# UNITED STATES PATENT AND TRADEMARK OFFICE

APPLICATION NO.	FILING DATE	FIRST NAMED INVENTOR	ATTORNEY DOCKET NO.	CONFIRMATION NO.
10/599,453	07/12/2007	Tsugunori Konakawa	89277.0109	9180
26/021 7590 05/13/2009 HOGAN & HARTSON L.L.P. 1999 AVENUE OF THE STARS SUITE 1400 LOS ANGELES, CA 90067				
EXAMINER				
COLEMAN, KEITH A				
ART UNIT		PAPER NUMBER		
3747				
MAIL DATE		DELIVERY MODE		
05/13/2009		PAPER

# Office Action Summary

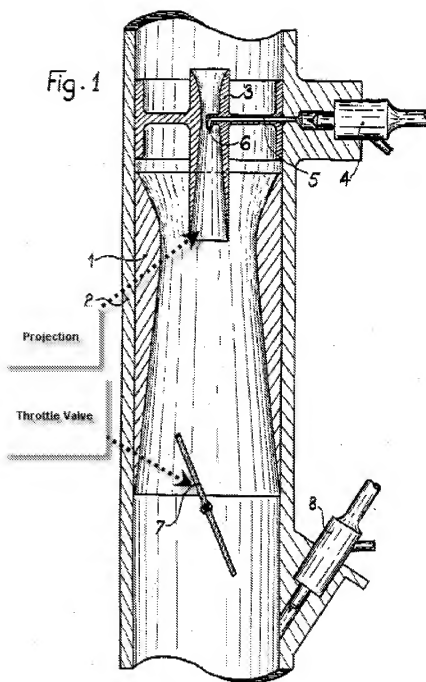
Applicant has amended the claim language to include "an intake passage protecting into the air cleaner chamber from the outlet and having, an opening opened to the air cleaner chamber, the intake passage comprising a throttle valve therein, wherein the air and the fuel in the air cleaner chamber are led to the engine through the intake passage." in claim 1 and further added claim 28.

With regards to the newly added limitation, the patent to Rivere ostensibly shows the claimed subject matter.
